TRANSMITTAL OF REV 1 PAGE CHANGES TO THE DECOMMISSIONING CLOSEOUT REPORT FOR THE 779 CLOSURE PROJECT- JLS-020-00

The purpose of this correspondence is to transmit Rev 1 page changes to the subject 779 Closure Report. These page changes incorporate Colorado Department of Health & Environment (CDPHE) comments to the Rev 0 Report dated April 2000, which was submitted to RFFO on May 24, 2000.

Attachment 1 includes the comments received from CDPHE, with the K-H written responses following each comment. The responses were reviewed and concurred with by CDPHE on November 30, 2000.

FIGURE 1-1, Building 779 Cluster Layout

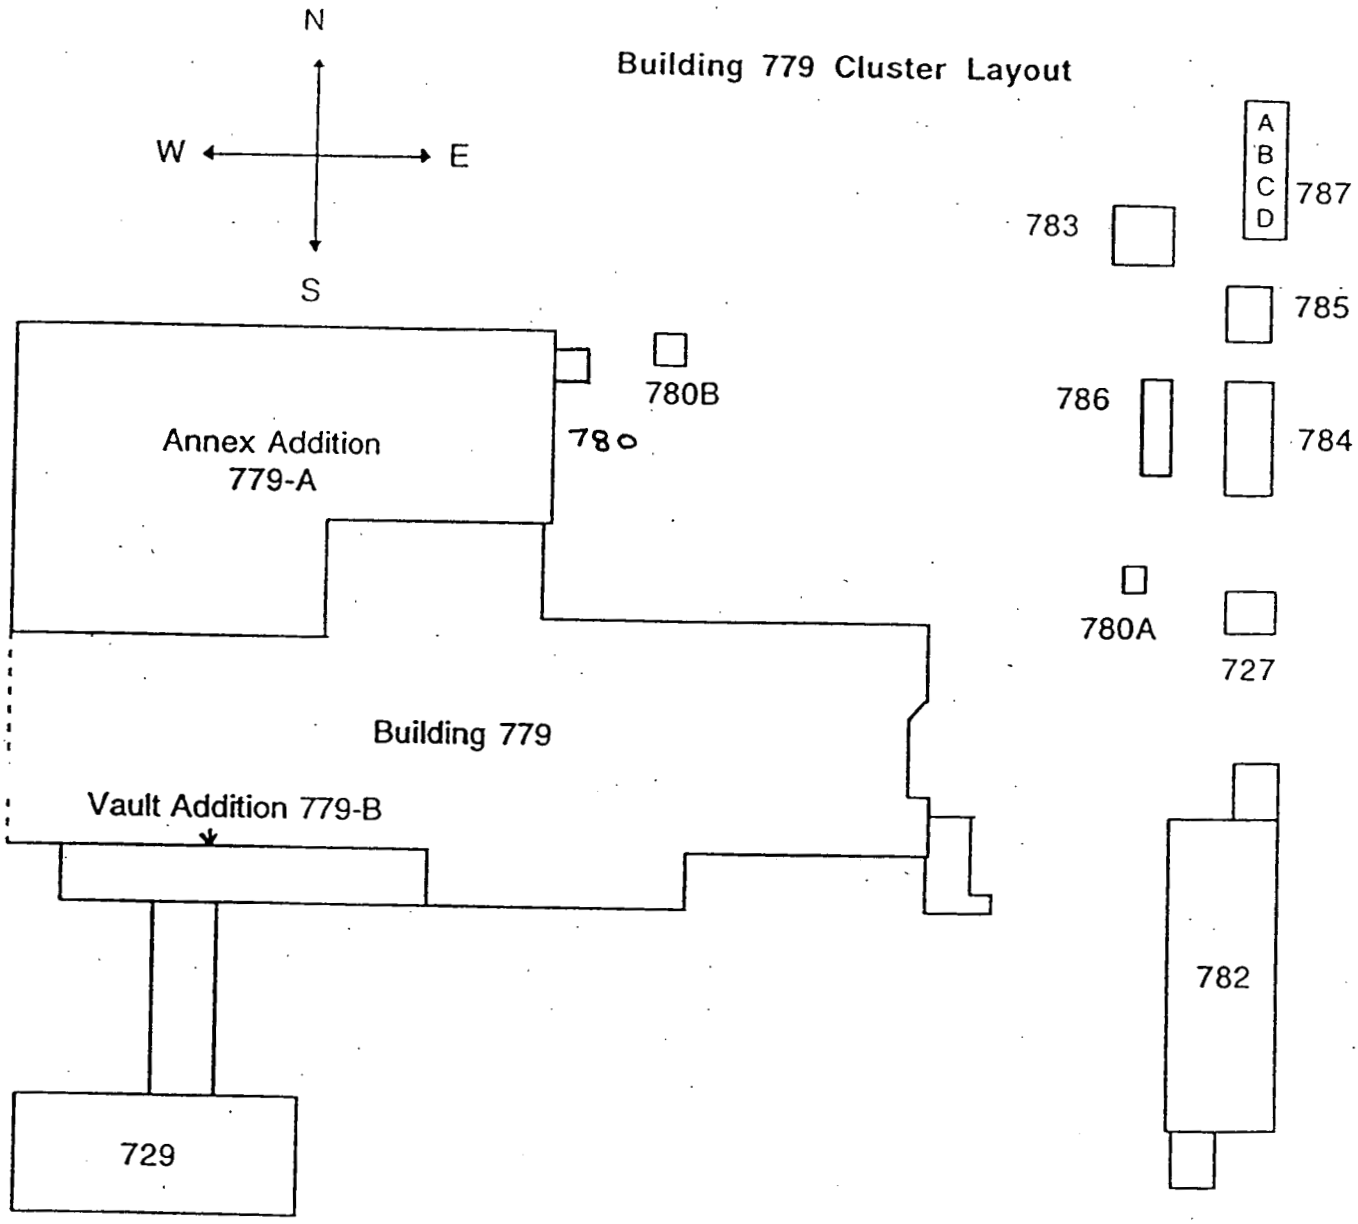
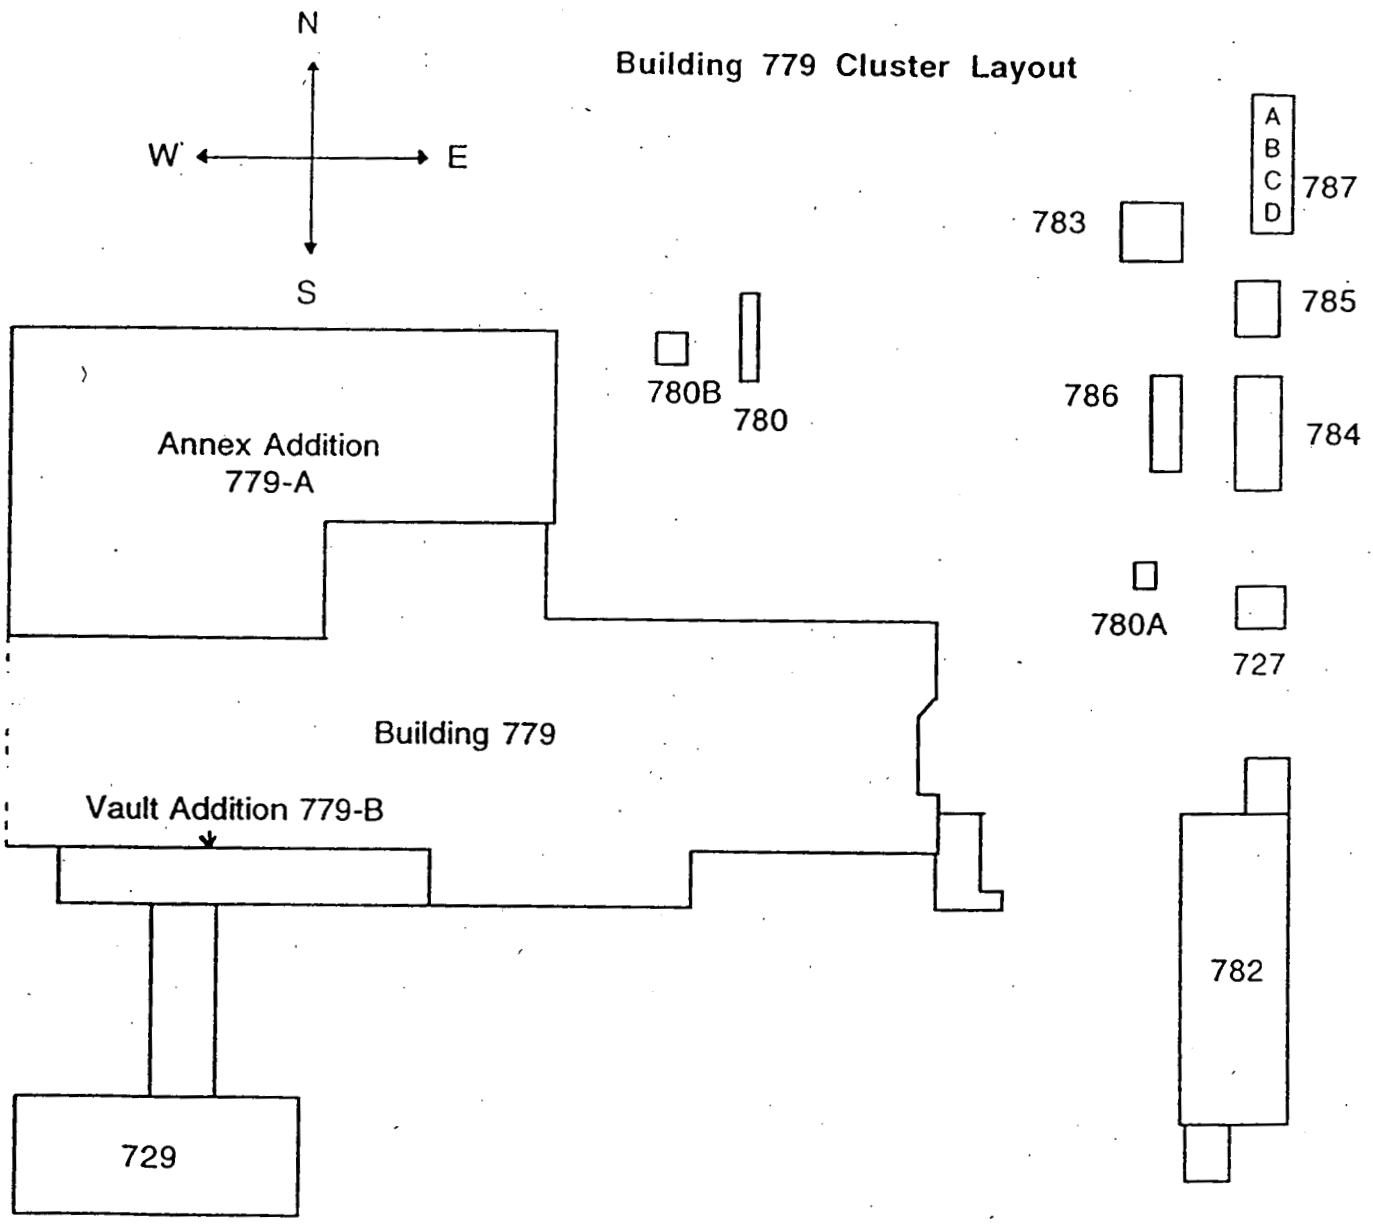
8) Page 19 - This section needs to include all remaining structures. It is stated on page 6 that the slab for B780 was left in place. As such, the B780 slab needs to be included and shown on a drawing (such as one in the appendixes).

Response
A discussion of the B780 slab has been incorporated, including slab dimensions(Page 18). Location of the slab is indicated on Figure 1-1.
